## V2500-A1/A5 SERIES PROPULSION SYSTEMS SERVICE BULLETIN

This document transmits Revision 2 to Service Bulletin V2500-ENG-24-0020 and Revision 2 to the Supplement

**V2500-NAC-24-0020**  
Transmittal - Page 1 of 1

NACELLE – POWERPLANT – ENGINE BUILT UNIT (EBU) – REPLACEMENT OF THE IDG EARTH STUD  
BRACKET

Replacement of the IDG Earth Stud Bracket  
Figure 1 sheet 1

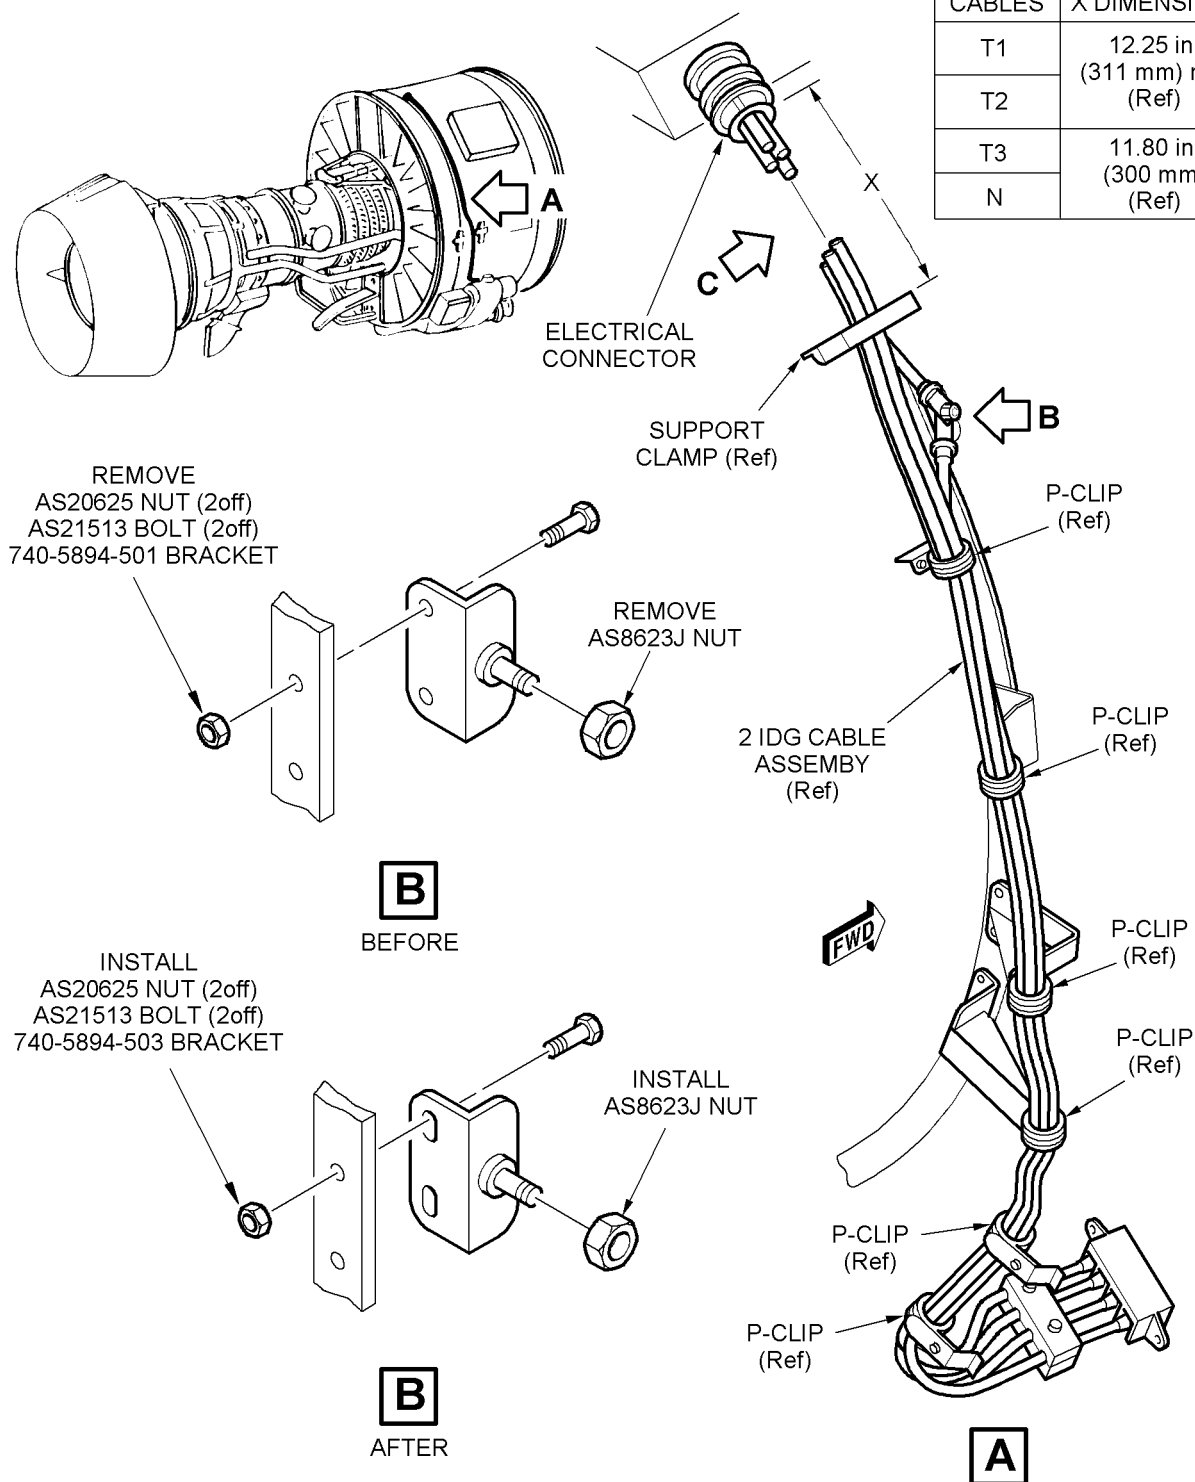
- (1) Loosen the two bolts that attach the Support Clamp to the Engine to allow adjustment of the IDG Harness. Refer to Figure 1 sheet 1.
- (2) At six locations, loosen the bolt that attaches the p-clip to the Engine to allow adjustment of the IDG Harness.
- (3) Confirm that the IDG Electrical Connector is correctly installed to the Pylon Receptacle.

- (8) Install the new 740-5894-503 Bracket to the Engine Flange with the two AS21513 bolts and the two AS20625 nuts. To allow adjustment of the bracket position, do not torque the bolts.

Replacement of the IDG Earth Stud Bracket  
 Figure 1 sheet 2

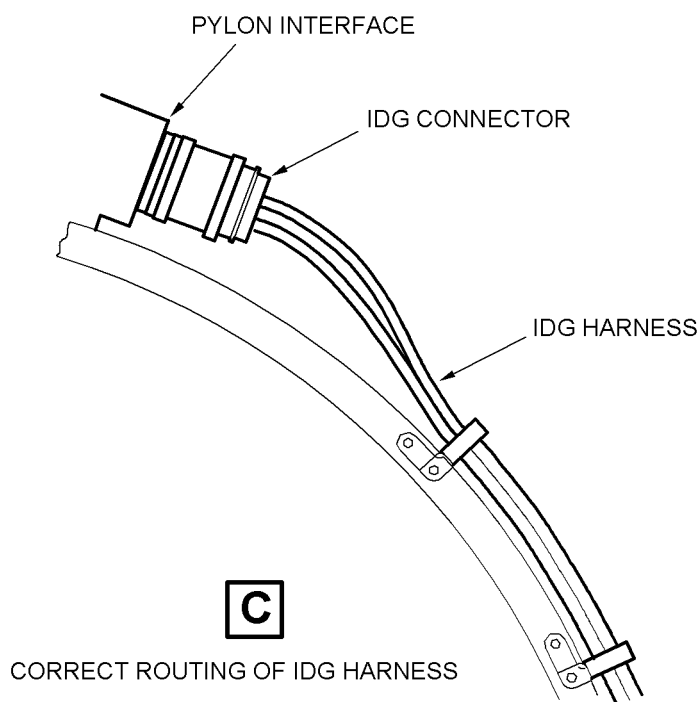
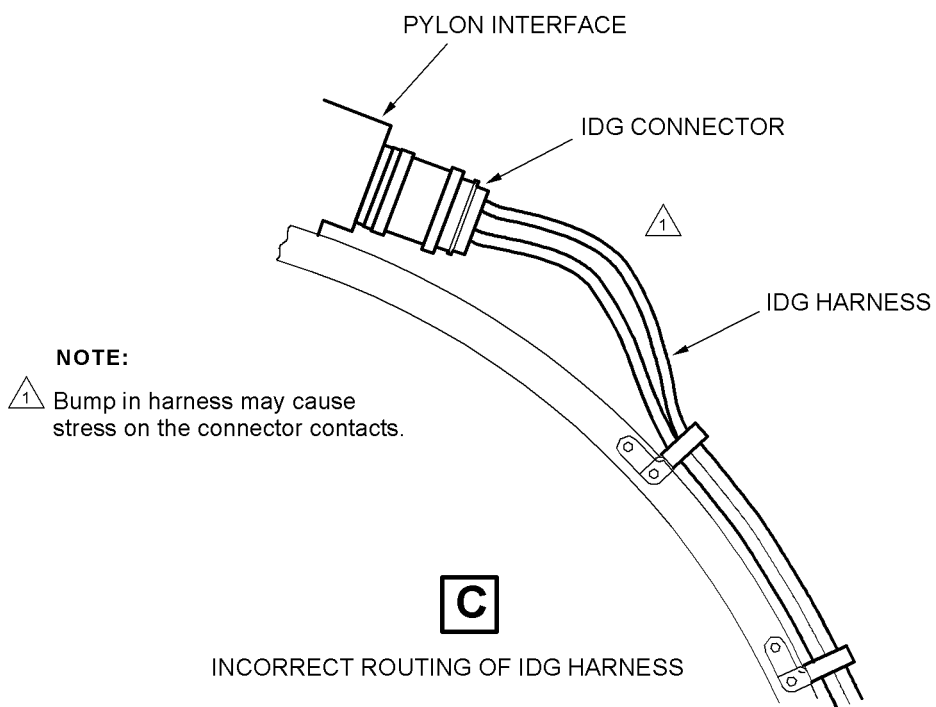
- (11) Confirm that there are no excessive bends in the harness routing between the Pylon interface and the new Bracket. Refer to Figure 1 sheet 2.

NOTE: To remove excessive bends, adjust the IDG Harness routing and bracket position.
